The Enclave at
Stonebridge
At Meridian
Ranch

Final Landscape Plan

DATE: January 1, 2018
PROJECT MGR: A. Barlow
PREPARED BY: M. Swift

LANDSCAPE DETAILS

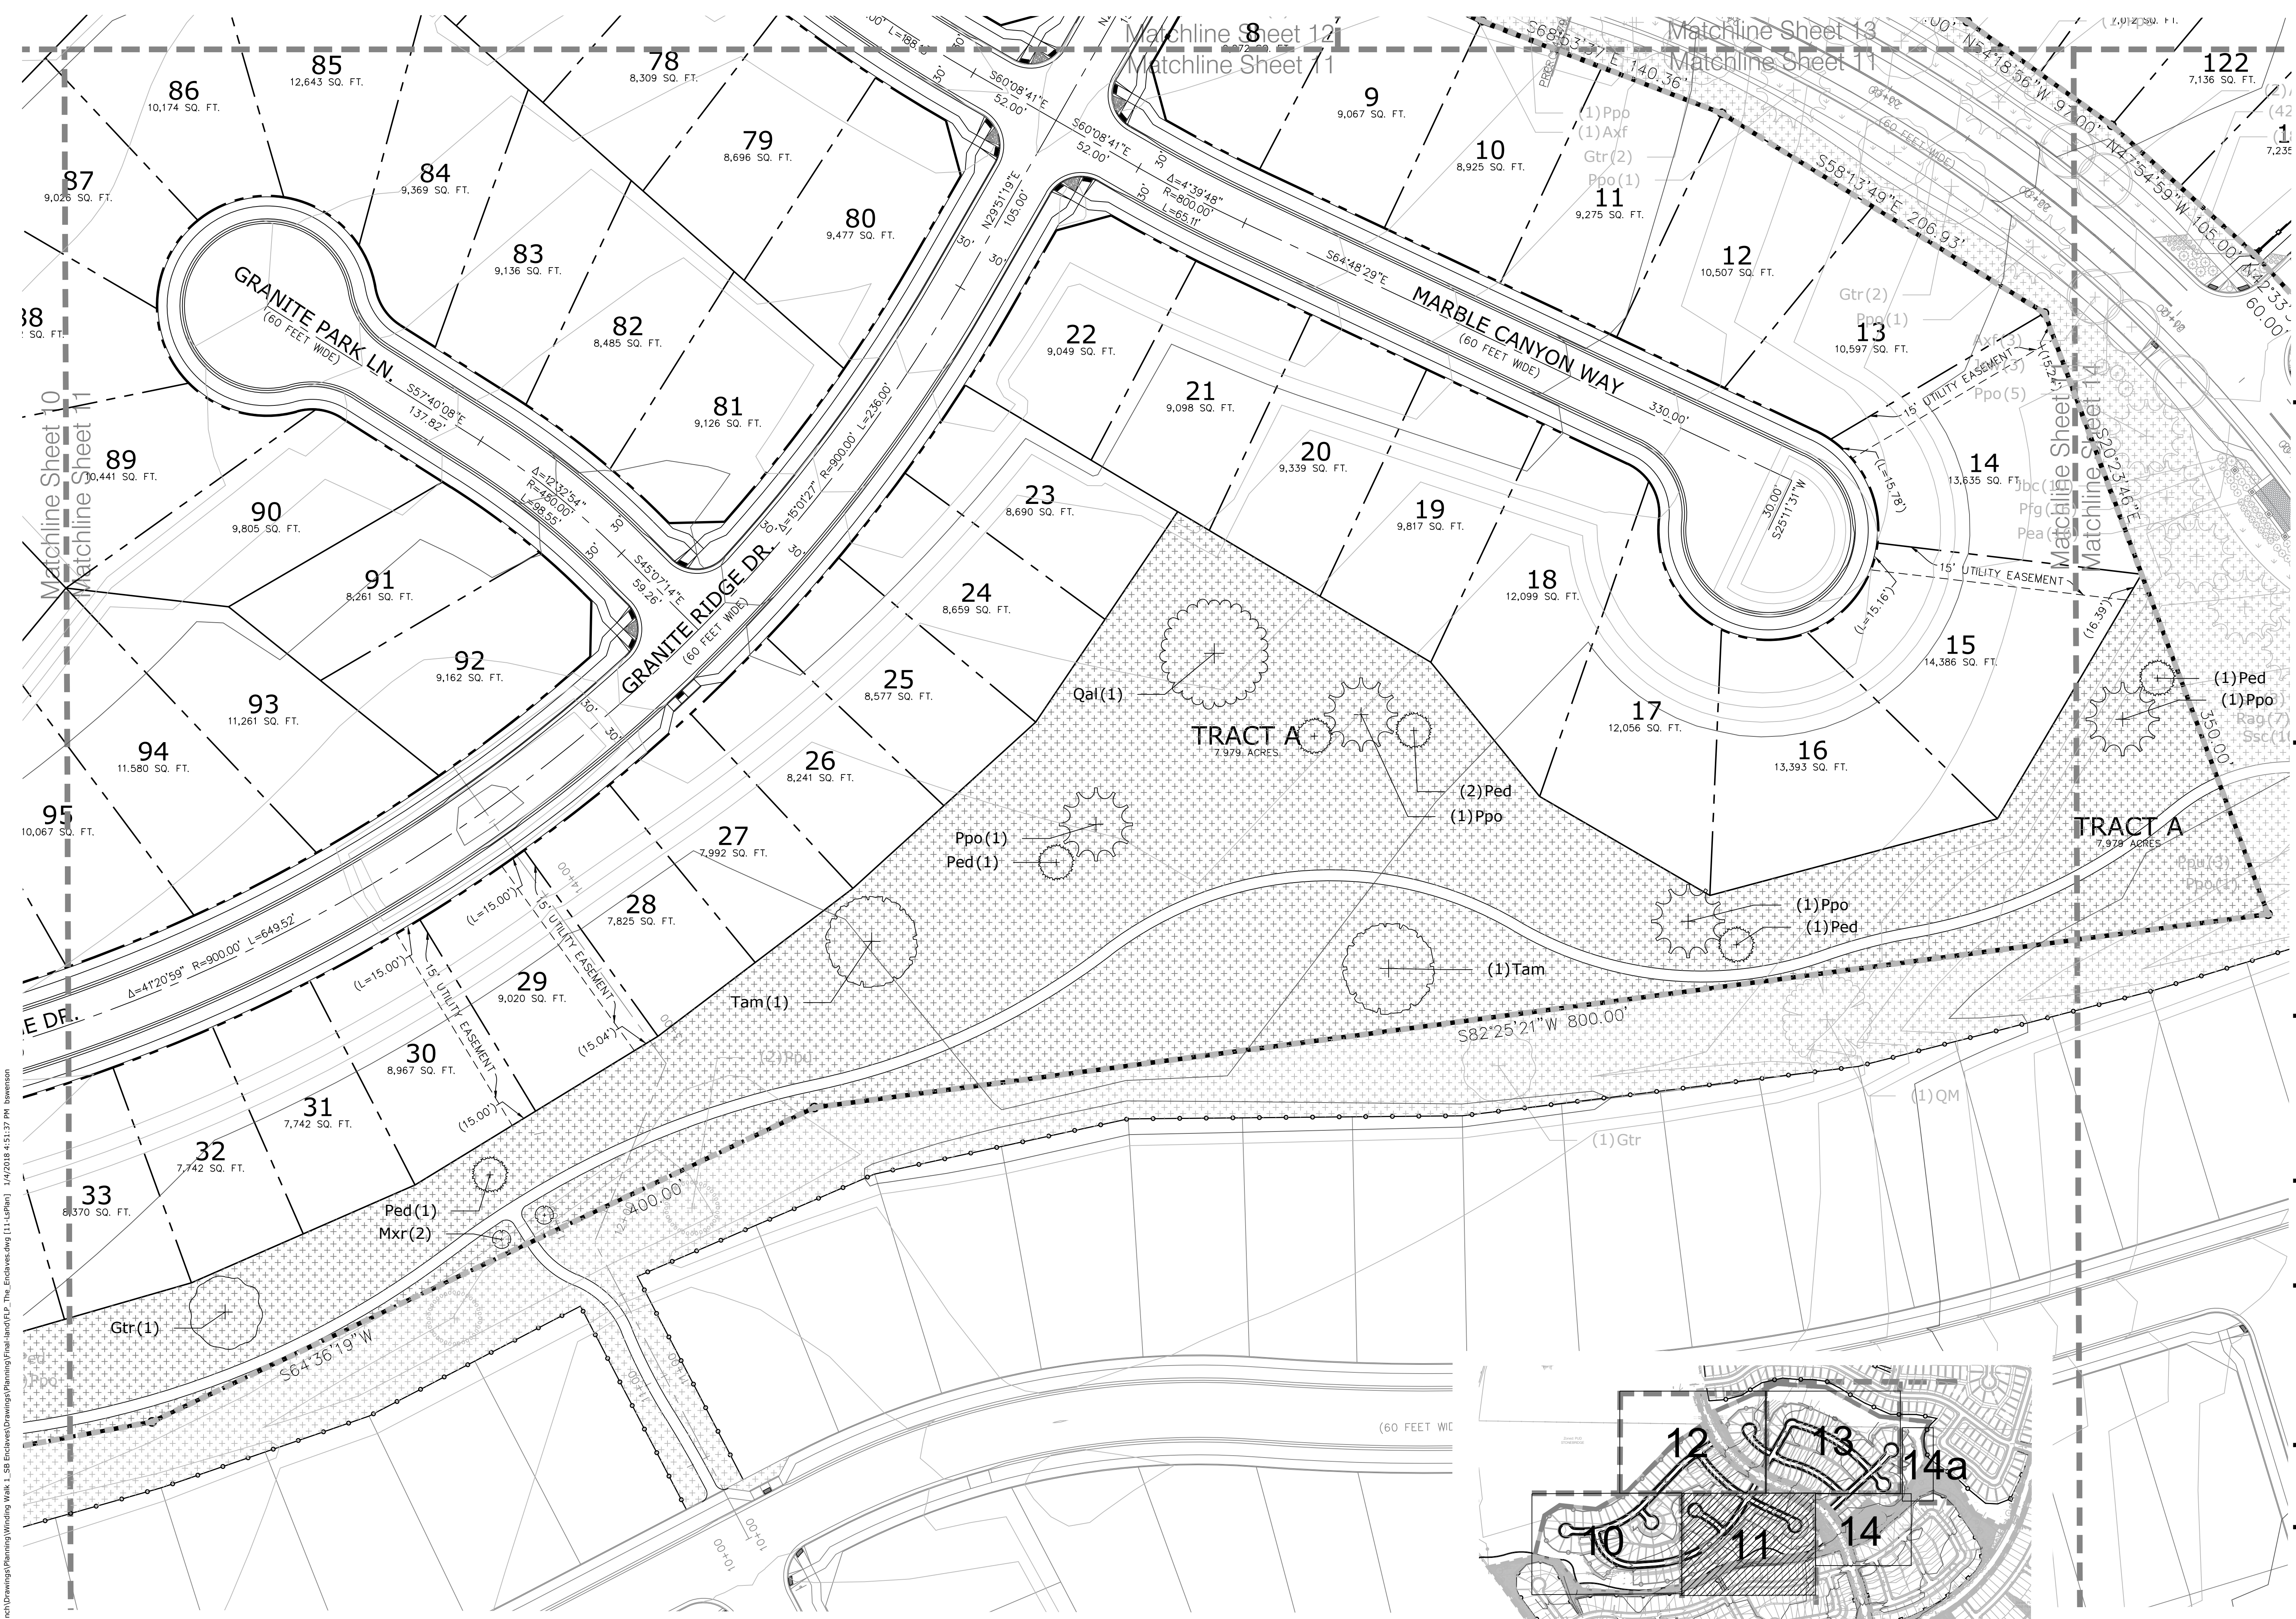
Please fill in and include chart for entire PUDSP area.
